### APPEAL SUMMARY

<b>Appeal ID:</b> 26327	<b>Project Address:</b> 5403 & 5413 SE 122nd Ave
<b>Hearing Date:</b> 12/8/21	<b>Appellant Name:</b> David Horsley
<b>Case No.:</b> B-002	<b>Appellant Phone:</b> 5033883680
<b>Appeal Type:</b> Building	<b>Plans Examiner/Inspector:</b> Anne Schmidt
<b>Project Type:</b> commercial	<b>Stories:</b> 4 <b>Occupancy:</b> R-2 Primary <b>Construction Type:</b> V-A
<b>Building/Business Name:</b>	<b>Fire Sprinklers:</b> Yes - NFPA 13 throughout
<b>Appeal Involves:</b> Erection of a new structure	<b>LUR or Permit Application No.:</b>
<b>Plan Submitted Option:</b> pdf [File 1] [File 2] [File 3] [File 4]	<b>Proposed use:</b> Multifamily housing (affordable)

## POWELLHURST APTS

DRAWING TITLE: GARAGE OPENNESS

1 OVERALL STAIR EXITING PLAN - GROUND FLOOR  
SCALE : 1/16" = 1'-0"

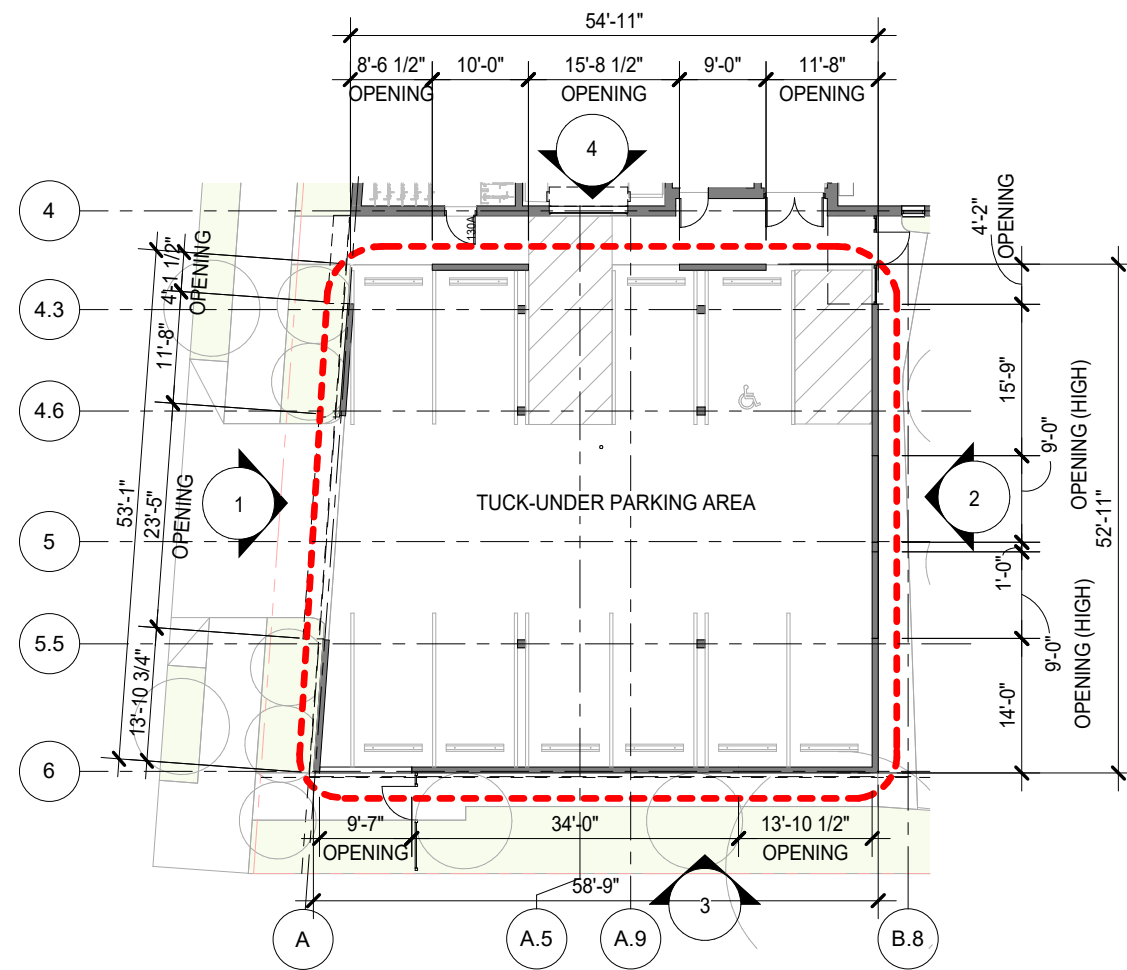
<b>Code Modification or Alternate Requested</b>	We request that egress from an interior exit stair, discharged to the exterior under a small building overhang, to be allowed in addition to the use of 1028.1 Exception 1, which will be applied to the exit discharge from the other interior exit stair.

<b>Proposed Design</b>	<p>The proposed building is a 4-story, Type V-A, affordable apartment complex, configured with an open courtyard facing the south. The building is sprinklered throughout with a NFPA 13 system. The building has two interior exit stairs, one at the West wing (Stair 2) and one at the East wing (Stair 1, which also has an adjacent elevator serving all floors). (See Exhibit 1.) This appeal requests that as configured Stair 1 is considered a direct discharge to the building exterior for the purpose of satisfying OSSC 1028.1, leaving the use of 1028.1 Exception 1 for the exit discharge from Stair 2.</p> <p>The proposed design provides egress from Stair 1 under a small building overhang, which is directly adjacent to a large exterior courtyard (see Exhibit 2). This overhead soffit, as well as the surrounding exterior building walls, will be 2-hour fire rated (in addition to the 2-hour enclosure of the interior stairs). This appeal requests that this exit configuration is considered a direct discharge to the building exterior for the purpose of satisfying OSSC 1028.1.</p> <p>Stair 2 provides egress from the building into a covered (but open to the exterior) tuck-under parking garage, which has a direct path to a public way, SE 121st St. This exit discharge meets all of the requirements of OSSC 1028.1, Exception 1. First, it provides a free and unobstructed path of travel from the exterior exit door. The second exception is not applicable (slab on grade). Third, it is protected by an NFPA 13 sprinkler system. Fourth, it is separated from Stair 1 by +/- 89', which is greater than ¼ the overall diagonal dimension of the building (208' / 4 = 52').</p>

<b>Reason for alternative</b>	<p>After leaving the two-hour fire-rated stair enclosure, occupants exiting Stair 1 would then be protected by the two-hour enclosure of the alcove (further described above), and have a +/- 5' travel distance to the open courtyard. The adjacent fire riser room (with 90-min. rated door) is a low-risk space, and will not contain or have the possibility to be used for storage of flammable materials as this is only accessed by fire personnel. Once in the courtyard, occupants would have two possible egress paths through gates equipped with exit hardware at the SE and SW corners of the site. Given the level of protection provided to occupants in combination with the extremely short length of the discharge distance, this configuration provides equivalent life safety to that required by code.</p>
-------------------------------	---

**1. Determination of Stair 1 as a direct exit discharge with path of egress beneath building overhang: Granted provided a minimum of one sprinkler head is installed below the soffit and provided door 100B is equipped with a closer and additional Type 13 sprinkler protection is installed on the occupied side of the non-rated lobby glazing adjacent to door 100B. Sprinklers are to be spaced not more than 6 feet apart and placed a minimum of 6 inches and a maximum of 12 inches from the opening(s) and a maximum of 12 inches below the ceiling. A separate permit from the Fire Marshal's Office is required.**

EX. 3

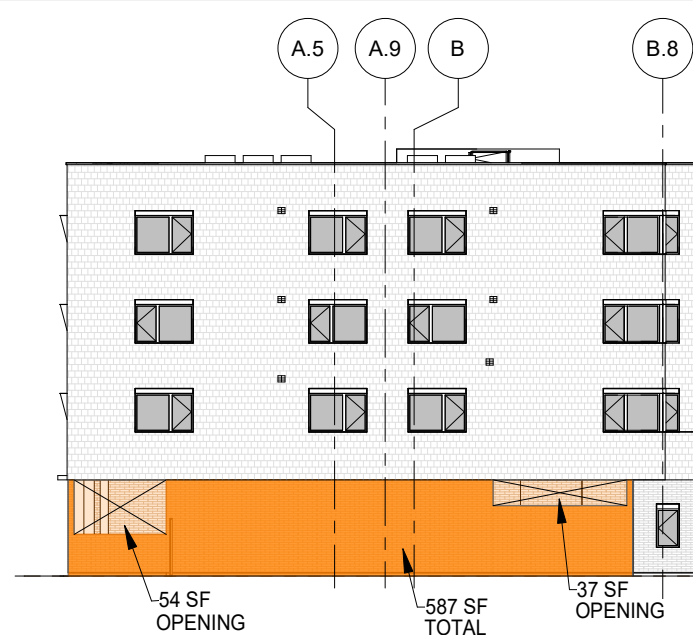
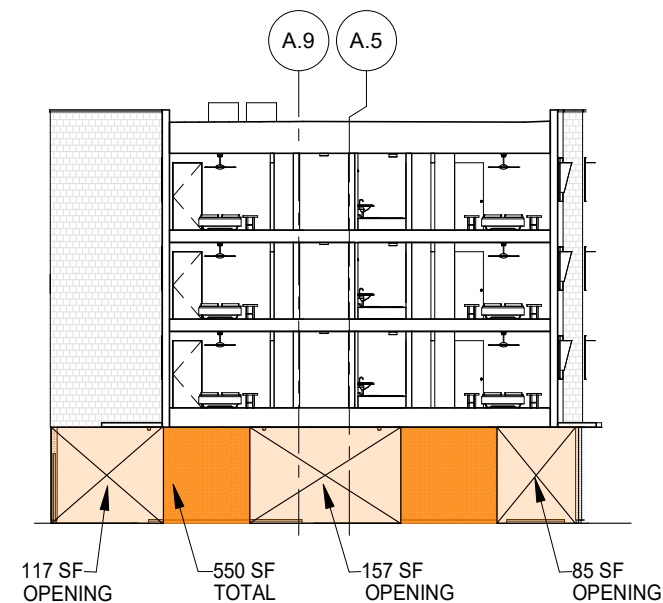
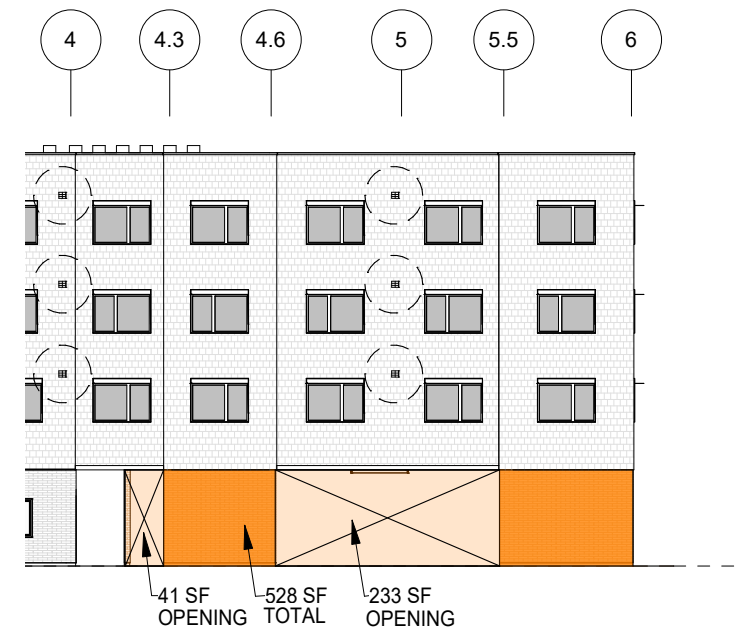
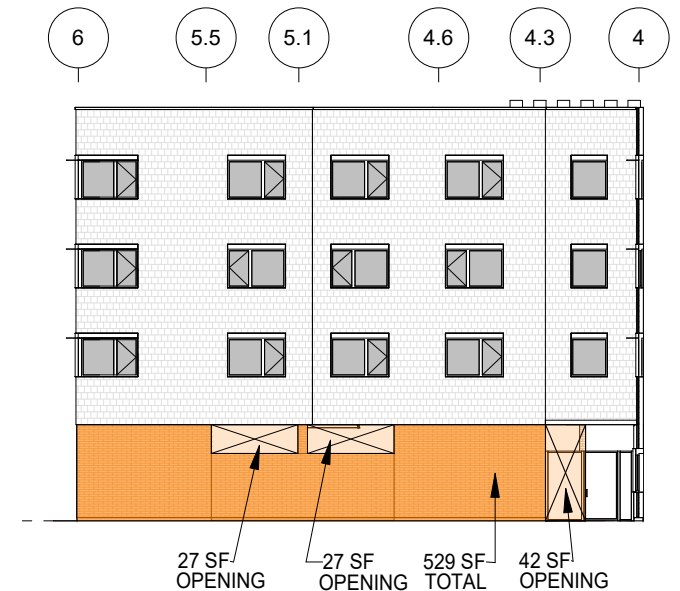
<b>Proposed Design</b>	<p>The proposed tuck-under parking garage is constructed of brick masonry walls with large openings (see Exhibit 3). The ceiling/floor above is a 1-hour fire rated assembly, above which is three stories of wood framed, Type V-A apartment units. The proposed design provides 37% open perimeter wall area, exceeding the 20% requirement per 406.5.2. Though not explicitly required because openings are provided on two opposing sides, 49% open perimeter length is also provided, exceeding the 40% requirement.</p>

**Reason for alternative** The proposed design provides openings that exceed those required for an Open parking garage, eliminating the need for a mechanical ventilation system. This appeal does not propose that the design constitutes an Open parking garage, only that the configuration is sufficient to allow natural ventilation as a substitute for mechanical ventilation. Similar appeals have previously been granted (BDS Appeal numbers 13042, 14411).

OPEN PERIMETER PROVIDED= 49%

OPEN PERIMETER REQ'D= 40%, COMPLIES

OPEN AREA PERCENTAGE =  $866/2,194 = 37\%$

OPEN AREA PERCENTAGE REQ'D: 20%, COMPLIES

**2. Omission of mechanical ventilation in enclosed parking garage: Hold for additional information. See note below regarding the process for submitting additional information.**

ENLARGED TRASH CHUTE PLAN & ACCESS COMPARTMENT - TYP.@ FLRS 2-4

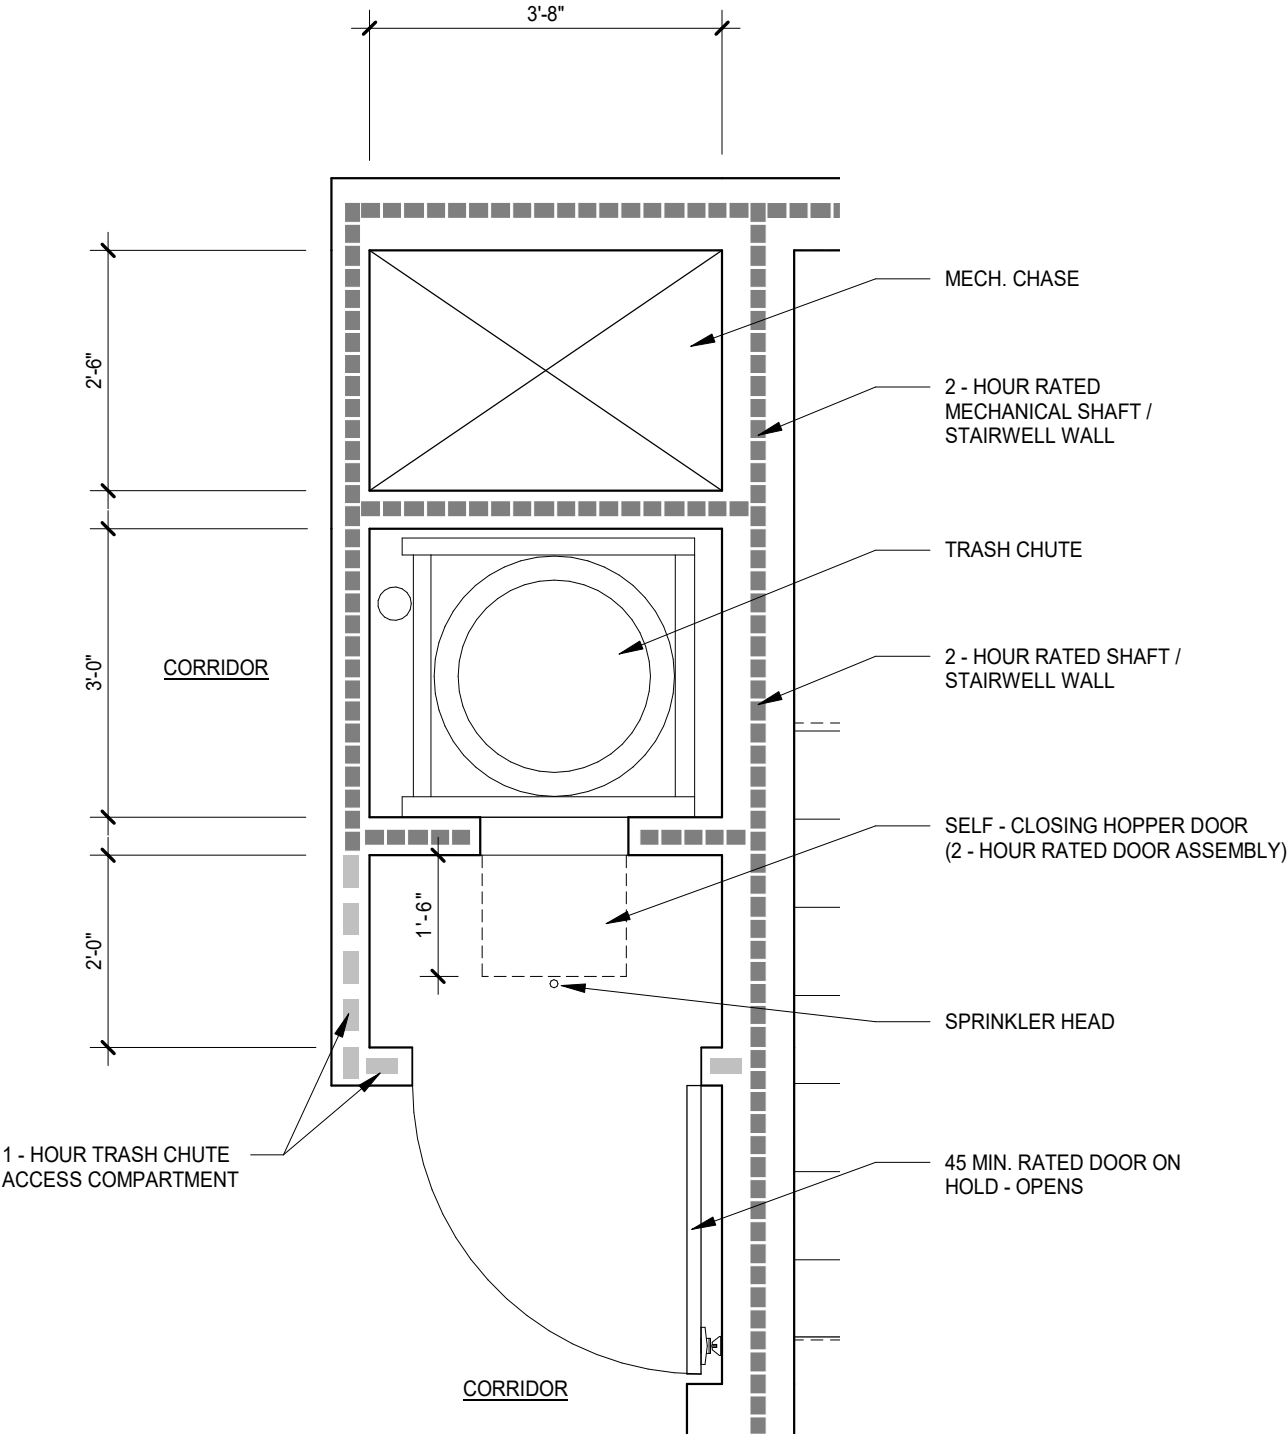
**Code Modification or Alternate Requested** We request to provide a trash chute access compartment, with access door on hold-opens, in lieu of a full trash chute access room.

**Proposed Design** The building trash chute serves 3 upper stories and terminates in a 2-hour rated trash room on the ground floor. We request to provide access to the trash chute from the building corridors on floors 2-4 via a 1-hour fire rated access compartment, the door of which will be 45-minute rated and on hold-opens (see Exhibit 4). The trash chute will fully compliant with building code, with 2-hour walls on all sides of the shaft and a self-closing hopper door. The access compartment door will be able to close with the trash chute hopper door in an open position, and a sprinkler head will be provided within the compartment.

**Reason for alternative** The compact nature of the projects' above-ground floors don't allow for a full trash chute access room, but do accommodate the more compact compartment configuration found on other similar projects. The proposed design provides equivalent life safety to that required by code, and has multiple granted appeals as precedent (BDS Appeal numbers 24789, 24035, 23747).

**3. Trash chute access compartment in corridor: Hold for additional information. See note below regarding the process for submitting additional information.**
